CITY OF ALBUQUERQUE

**Planning Department
Transportation Development Services**

**Re: Santuario de San Martin De Porres
8301 Camino de San Martin SW
30-Day Temporary Certificate of Occupancy- Transportation Development
Engineer's/Architect's Stamp dated 12-18-13 (M10-D002)
Certification dated 12-29-15**

RE: **TRAFFIC CERTIFICATION - Submittal**
Project: Santuario San Martin de Porres
8301 Camino de San Martin, Albuquerque NM 87121
DRB No. 1008137
Construction Permit 201492549

AS-101

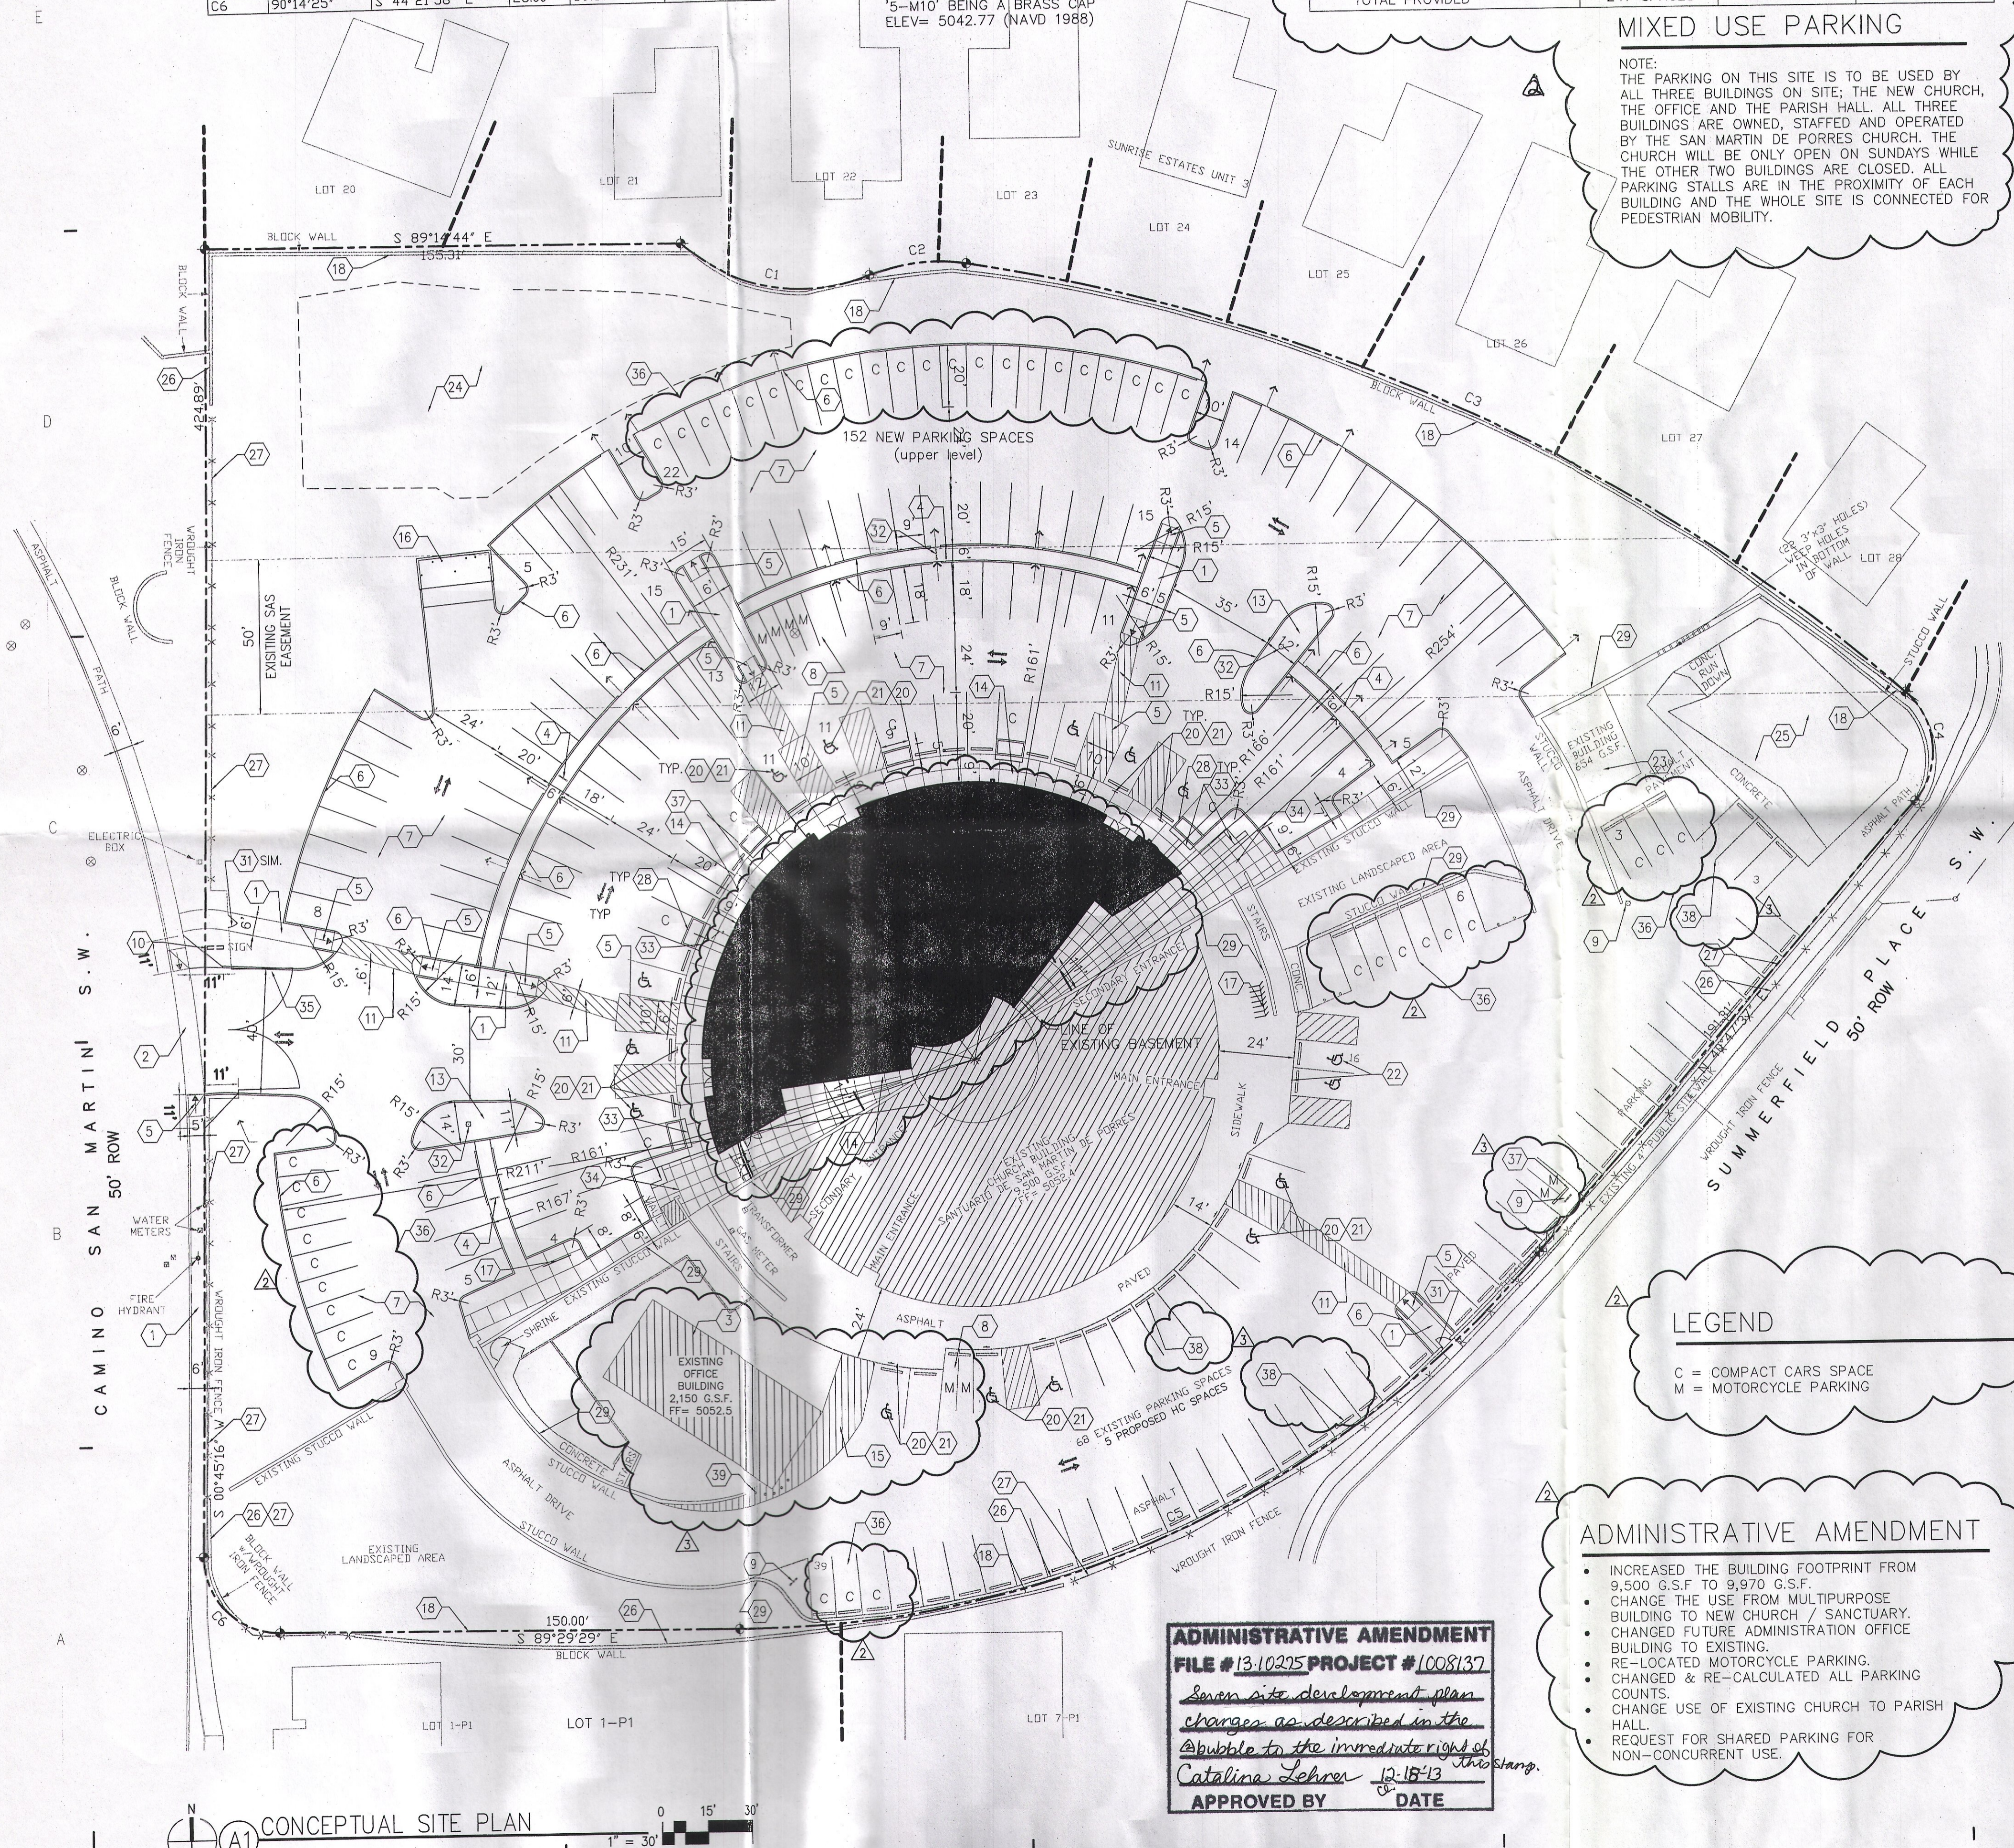
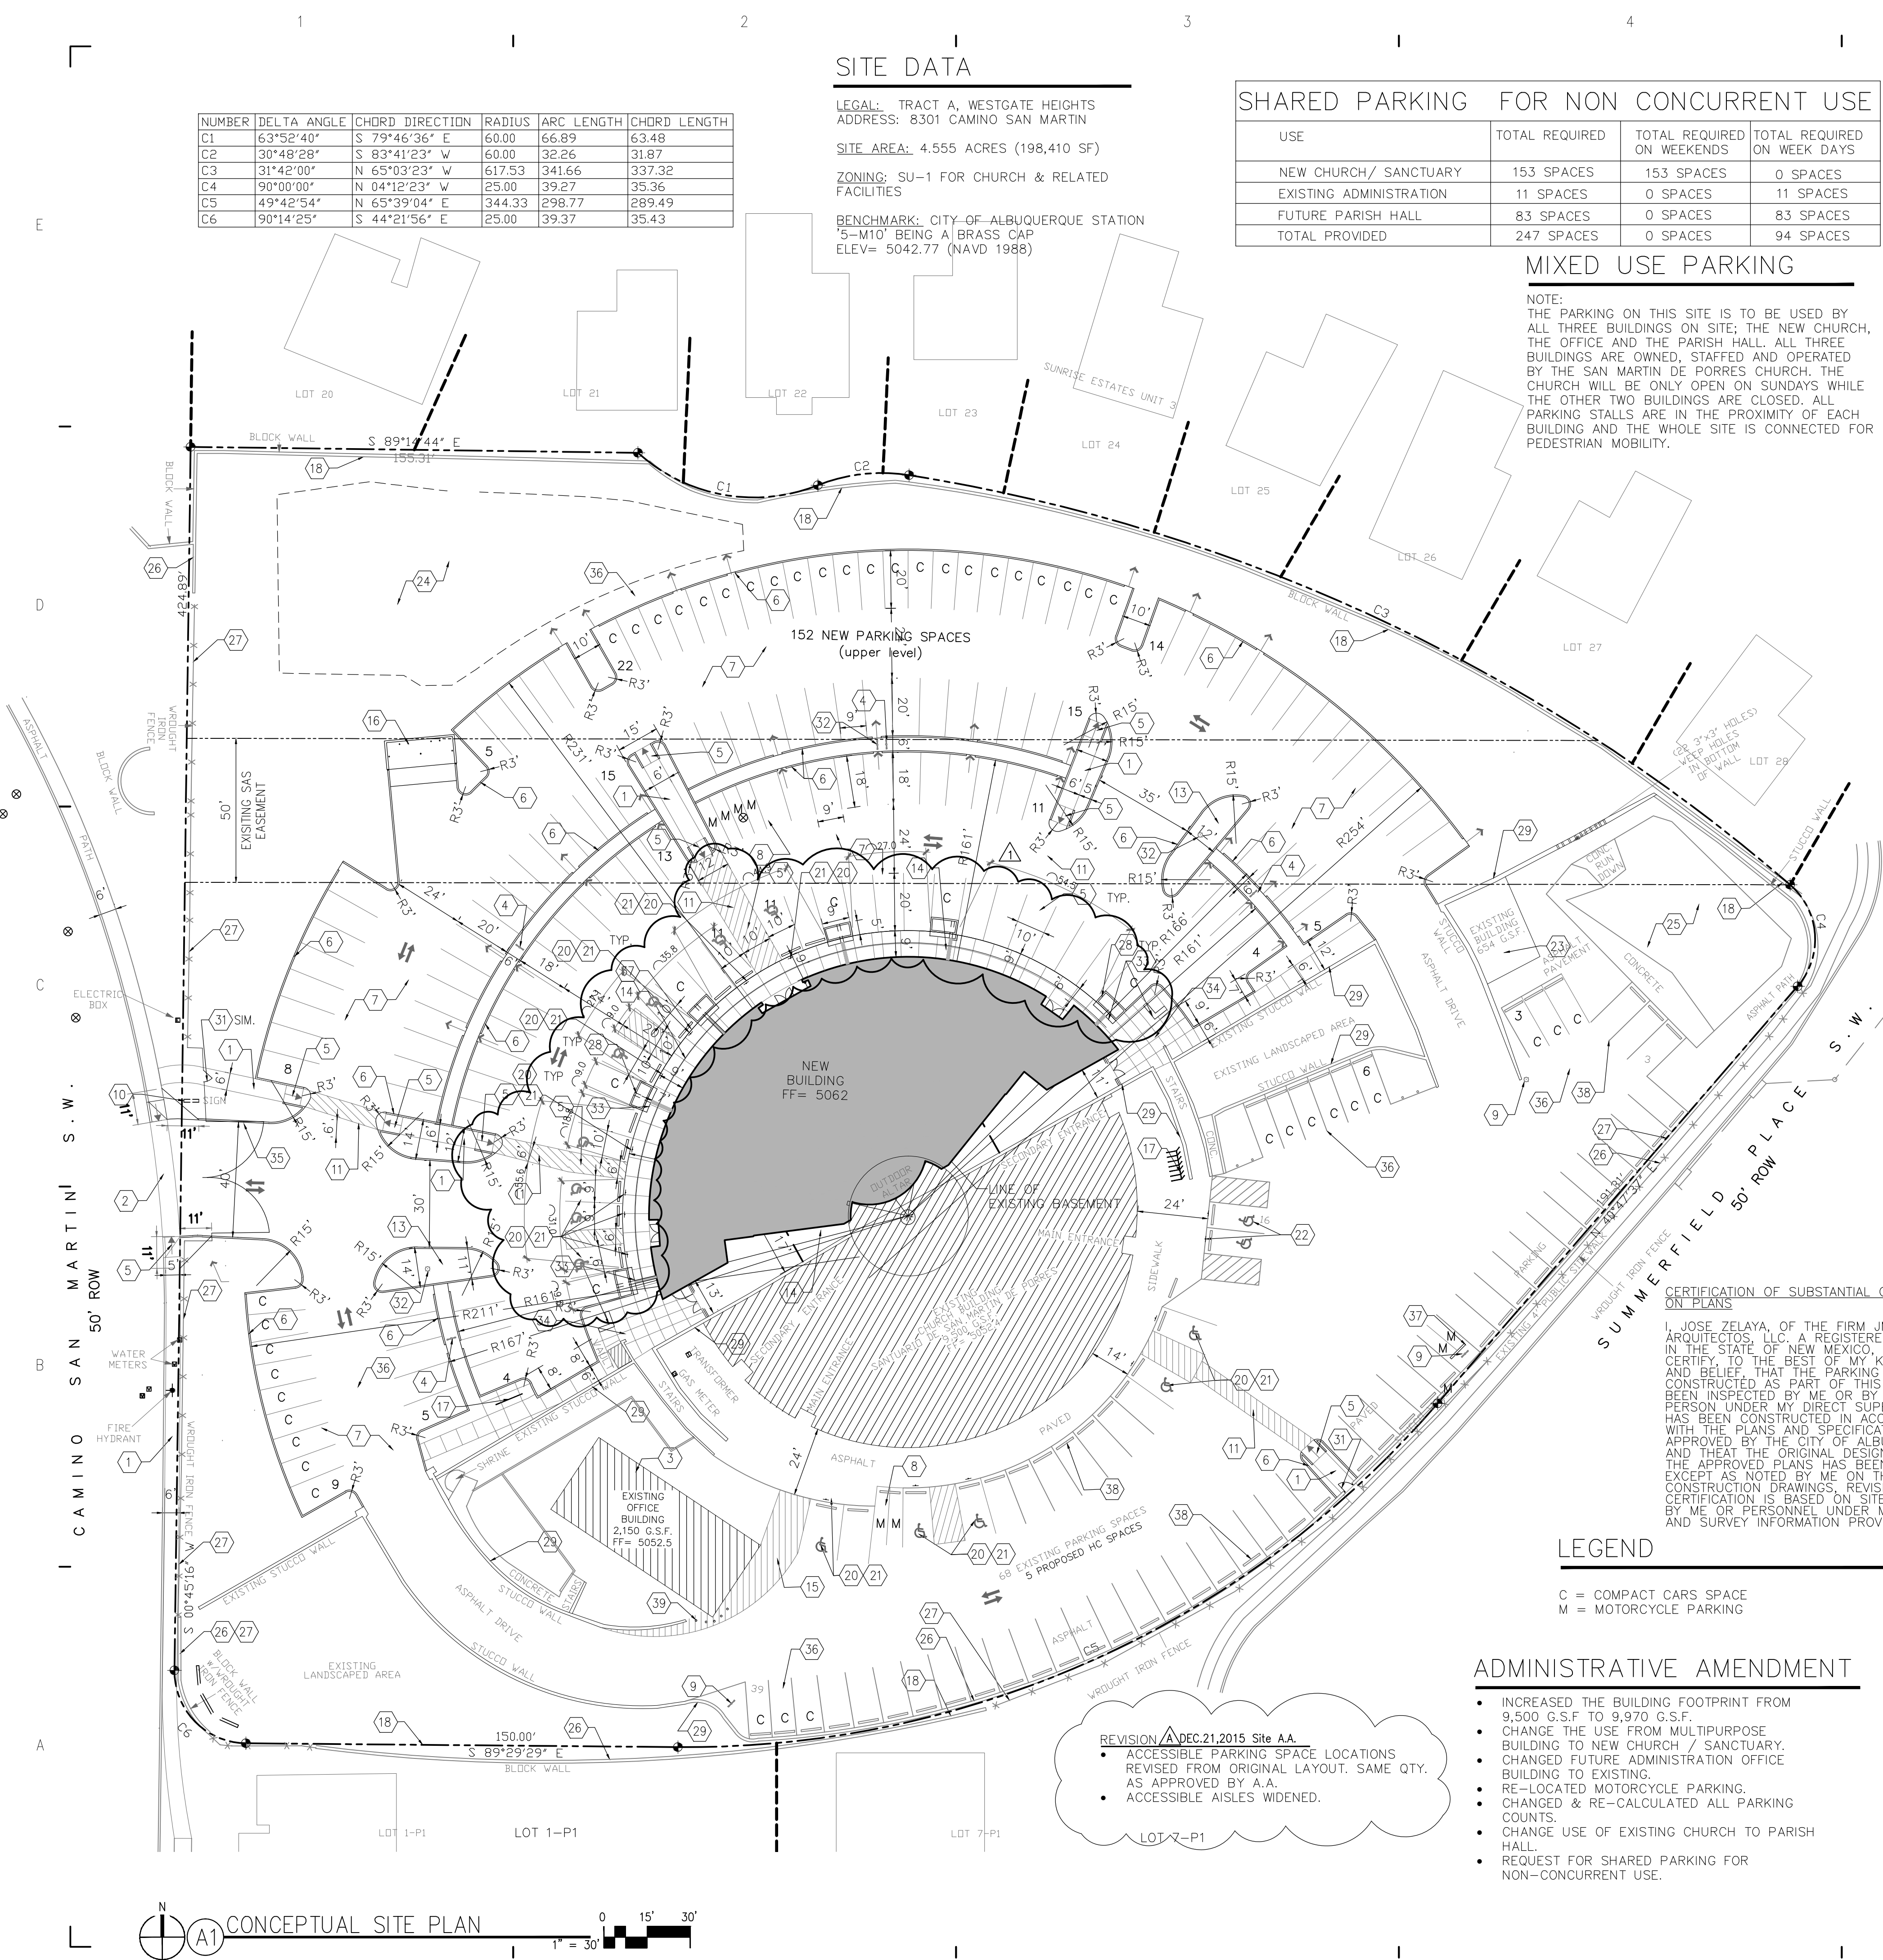
- The ADA accessible parking sign must have the required language per 66-7-352.4C NMSA 1978 **"Violators Are Subject to a Fine and/or Towing."**

The record information on AS-101R shows the changed locations of the accessible parking stalls along the clouded area dated Dec 21st 2015.

REVISION DEC 21, 2015 Site AA
ACCESSIBLE PARKING SPACE LOCATIONS REVISED FROM ORIGINAL LAYOUT. SAME QTY. AS APPROVED BY A.A.
ACCESSIBLE AISLES WIDENED.
